# CITY OF ALBUQUERQUE

**Re: Nusenda Credit Union**  
**2801 Juan Tabo Blvd. NE**  
**Traffic Circulation Layout**  
Architect's Stamp 07-06-22 (H21-D020)

Based upon the information provided in your submittal received 07-07-22, the above referenced plan cannot be approved for Building Permit until the following comments are addressed:

1 site plan  
A001 1"=20'

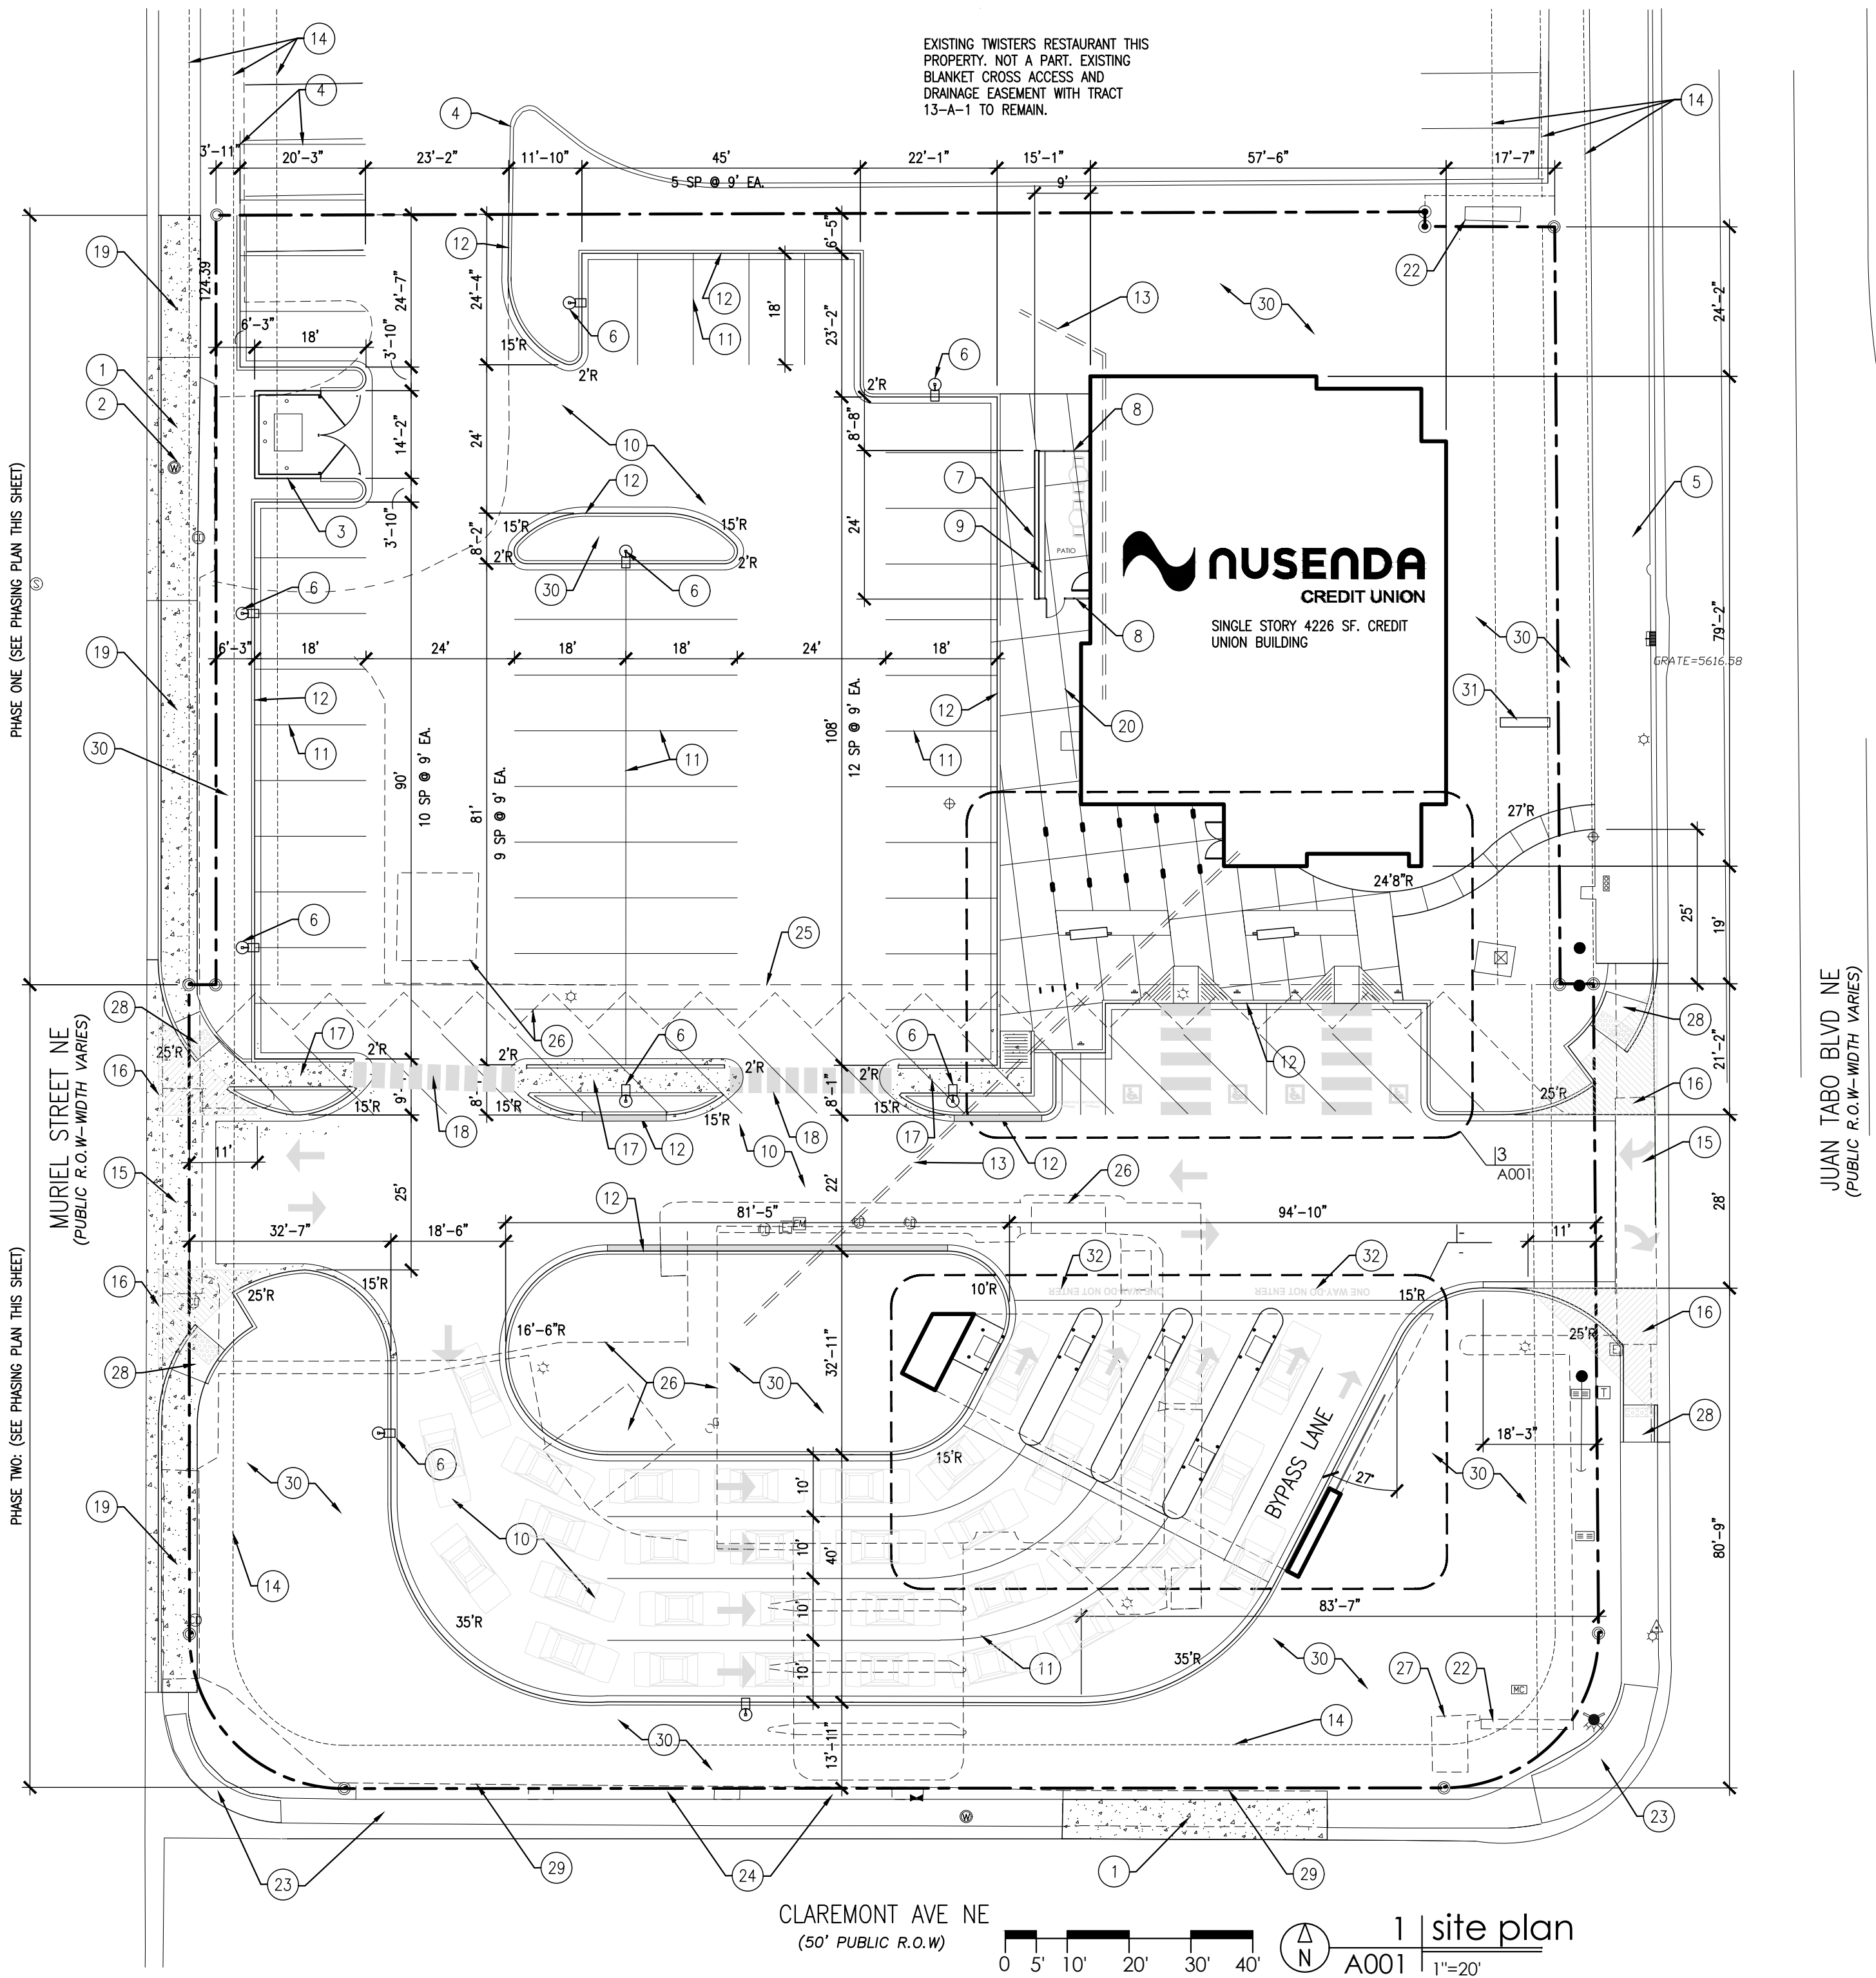
1. List the number of parking spaces required by the IDO as well as the proposed number of parking spaces including bicycle and motorcycle parking
2. Identify the right of way width, medians, curb cuts, and street widths on Juan Tabo Blvd. NE and Muriel St. NE

3. Driveway access off Juan Tabo and Muriel: ADA curb ramps and landing need to be located on the Public City Right Of Way.
4. Please provide details (slopes) for the proposed ADA ramps inside the property.

5. Sheet A002 is missing.
6. Keynote 1: reference COA std dwg 2430.
7. The ADA accessible parking sign must have the required language per 66-7-352.4C NMSA 1978 **"Violators Are Subject to a Fine and/or Towing."** Please call out detail and location of signs.

11. Bicycle parking spaces shall be at least 6 feet long and 2 feet wide.
12. Per the IDO, a 6 ft. wide ADA accessible pedestrian pathway is required from the public sidewalk to the building entrances. Please clearly show this pathway and provide details.

13. Per DPM, a 6 ft. wide ADA accessible pedestrian pathway is required from the ADA parking stall access aisles to the building entrances. Please clearly show this pathway and provide details.

14. ADA accessible pedestrian pathway should not be placed behind parking space or adjacent to a vehicular way. Vehicle and pedestrian/wheel chair conflicts should be avoided as much as possible.

15. All one-way drives shall have "One Way" and "Do Not Enter" signage and pavement markings. Please show detail and location of posted signs and striping.

16. The minimum drive through lane width is 12 feet with a 25 foot minimum radius (inside edge) for all turns. (A 15 foot radius can be used with an increase in lane width to 14 feet). Please dimension all lane widths and radii.

20. Add a note stating "All broken or cracked sidewalk must be replaced with sidewalk and curb & gutter." A build note must be provided referring to the appropriate City Standard drawing.
